**Proposal for a new UN Regulation on uniform provisions concerning the approval of motor vehicles with regard to the Moving Off Information System for the Detection of Pedestrians and Cyclists****Submitted by the Informal Working Group on Awareness of Vulnerable Road Users proximity in low speed manoeuvres**

### UN Regulation No. [XXX]

#### Uniform provisions concerning the approval of motor vehicles with regard to the Moving Off Information System for the Detection of Pedestrians and Cyclists

Figure 2  
Set Up for Longitudinal Cyclist Tests

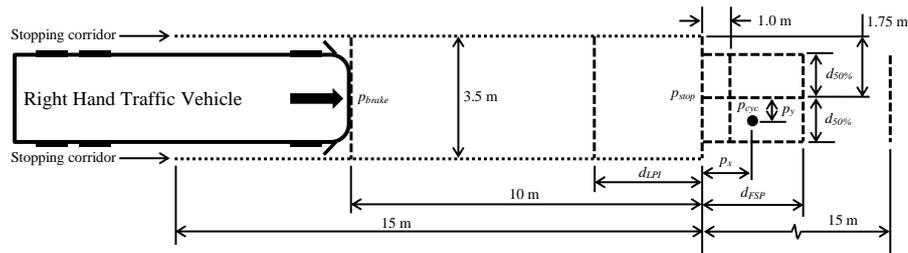
**Met opmerkingen [PV1]:** Clarifications required for the reference points, the detection area and the distances. To keep in mind that the testing procedure will be modified when we will have more experience on MOIS and testing procedure

**Met opmerkingen [PV2]:** Is it 0.0 or 0.1?
